CABINET MEMBER FOR ENVIRONMENT – 13 SEPTEMBER 2018 WHEATLEY – STATION ROAD - PROPOSED ZEBRA CROSSING

Report by Director for Infrastructure Delivery

1. This report presents responses received to a statutory consultation on a proposal to provide a zebra crossing on Station Road north of its junction with Farm Close Road.

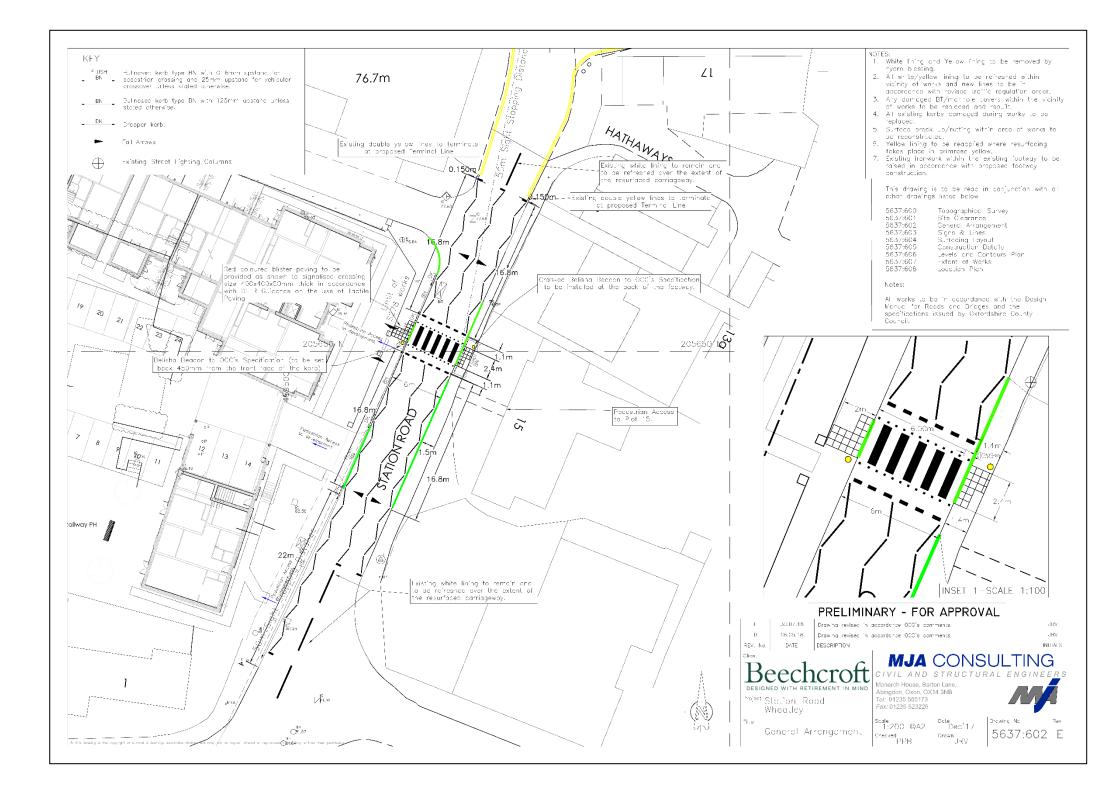
- 5. The three objections included expressions of concern that the crossing was not in the correct location stating that a site further north would be preferable. Concerns were also raised that it would present a hazard and increase difficulties for traffic progressing along Station Road, also those turning at nearby junctions and that its proximity to parking by the Co-op store would result in a hazard to those using the crossing.
- 6. Although the above concerns are noted, it is not considered viable to amend its siting taking account of the site constraints in the area and also noting that the crossing is being provided through the development of adjacent land and that the current positioning reflects the likely desire line of the occupants of

| RESPONDENT | SUMMARISED COMMENTS |
|-----------------------------------|--|
| (1) Local Resident, (Wheatley) | Object - The zebra crossing would be better suited at the bottom of Station road where it is very difficult for parents and young children especially, to cross the road with 4 directions of traffic flow. The zebra crossing being placed in your proposed position would also create a hazard due to the number of vehicles parking on the yellow lines on both sides of the road to use the Coop. By putting a zebra crossing here will mean pedestrians having to enter the road in to oncoming traffic from behind or in front of parked cars not allowing enough visibility of traffic especially considering the speed at which some vehicles travel on that road it is an accident/death waiting to happen. No amount of double yellow lines will stop cars from parking there due to the sheer convenience of its placement. |
| (2) Local Resident, (wheatley) | Object - Support that a Zebra crossing is needed on Station Road - however this is the wrong position. It is needed further down the road near the High street - suggest nearing fish and chip shop, to safely allow pedestrians particularly schoolchildren to cross the road. |
| (3) Local Resident, (Wheatley) | Object - I object to this crossing due to the impact on the traffic coming up and going down Ladder Hill and to the traffic coming out of Farm Close Road. As someone who uses that road frequently there is not the need for a zebra crossing there. |

| (6) Local Resident, (Wheatley) | Support - I also strongly believe that Ladder Hill should all be a 20mph zone, to discourage speeding. |
| (8) Local Resident, (Wheatley) | Support - As a mother of 2 young children I find the lack of crossings (and narrow pavements) make it difficult to safely get around Wheatley with my children on foot. This crossing is on the route we sometimes take home from the children's primary school and I do not feel particularly comfortable crossing with them here currently, the proposed crossing would definitely be an improvement. |
| | The markings preventing cars from parking in the immediate vicinity of the crossing would also be a benefit. Frequently cars and vans park on the road here while their owners visit the co-op. When vehicles are parked on this stretch the visibility for cars trying to turn right out of farm close road is very poor- it makes it impossible to see whether traffic is coming up the hill (which it frequently is). For both reasons I would welcome this crossing. I'd also like to see crossings in other locations around Wheatley and some of the stretches of pavement widened (particularly at the bottom of station road and along the high street). As a parent it's quite unnerving walking with young children on a narrow stretch of pavement where it would only take a small trip or moment of distraction for them to stumble straight into the path of oncoming traffic. I imagine this could also be an issue for the residents of the development, as I understand they will be for older people therefore potentially less mobile/ steady on their feet. |
| (11) Local Resident, (Wheatley) | Neither - I would think it far more beneficial if it could be located nearer the alley from Farm Close Road. Pedestrians going to/from the primary school would be more likely to use the crossing if it was further north. |
| | Also, the pavement on the west side (other side from co-op) is very narrow down to the High Street, so it would be |

this development. The design of the crossing has been safety audited, including consideration of its location in respect of side road junctions and adjacent accesses and parking for the Co-op store.
